Parks and Recreation Advisory Board

## MEETING MINUTES

# Sherwood Parks and Recreation Master Plan

**PARKS AND RECREATION ADVISORY BOARD**  
**FEBRUARY 1, 2021**

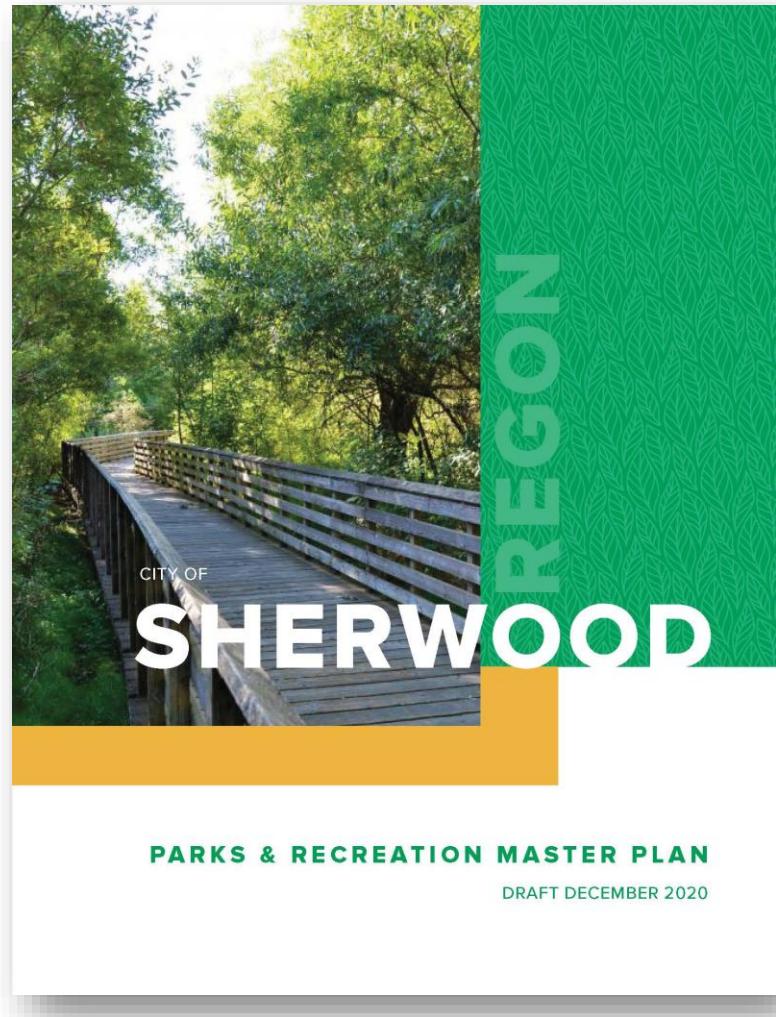
1. **Inside the cover:** Replace page 2 (large logo) with page 4 ('Sherwood Parks and Recreation Master Plan' with small city logo). This will correct the pixilation of the logo on page 2 and broken up page spreads (two page spreads for each chapters and maps/graphs) throughout the document.

2. **Page 9:** Move the 'Sherwood Field House' bullet to the top of the next column
3. **Figure 3 (page 11) and Figure 6 (page 17):** The legend text needs to be the same size and all the lines need to be the same size/pt.

4. **Figure 6 (page 17)**
  - a. Within the document there is an extra line that needs to be deleted between 'Railroad' and 'Mayor Streets'. The file that is JUST Figure 6 does not have this extra line.

- b. In the title, because OFFSTREET comes before a noun, it should be hyphenated.
  - c. The title of this map should be EXISTING AND PLANNED.
  - d. Cedar Creek Trail Phase 2 needs to be added.

- e. The Ice Age Tonquin Trail and the Oregon Street connection are mentioned on page 19 in the plan, so they should also be added to the map.
  - f. The legend indicates that Tualatin will be the color of grey on the map, but it is not. It IS grey on Figure 3; they need to match.

- g. Label 124<sup>th</sup>. It is right on the edge of the map, but is a major road that should be labeled.
5. **Figure 8:** It appears to be an image of one map inserted into another. At the bottom of the city limit box streets, street names, and the city limit border are all cut off.

6. **Figure 8:** in the legend it indicated that there is a 'Old Town Sherwood Overlay' but it is not shaded on the map.
7. **Figure 9:** 'Stella Olsen' and 'Snyder Park' are hard to read. The names need to be put to the side or outlined in white like in Figure 3.

8. **Recommended Improvements, TIER 1 through TIER 3, Pages 51-63:** All of the maps are impossible to read because they are so small. Maybe zoom into the park that is being discussed rather than the entire map.

9. **Page 68, Sports Field Complex, top paragraph:** In the text on the page, it mentions planning for 3 fields (more if site is large enough), but in Figure 1, the Executive Summary, the Sports Complex line item mentions 6 fields. Its seems these should be more in synch with each other.
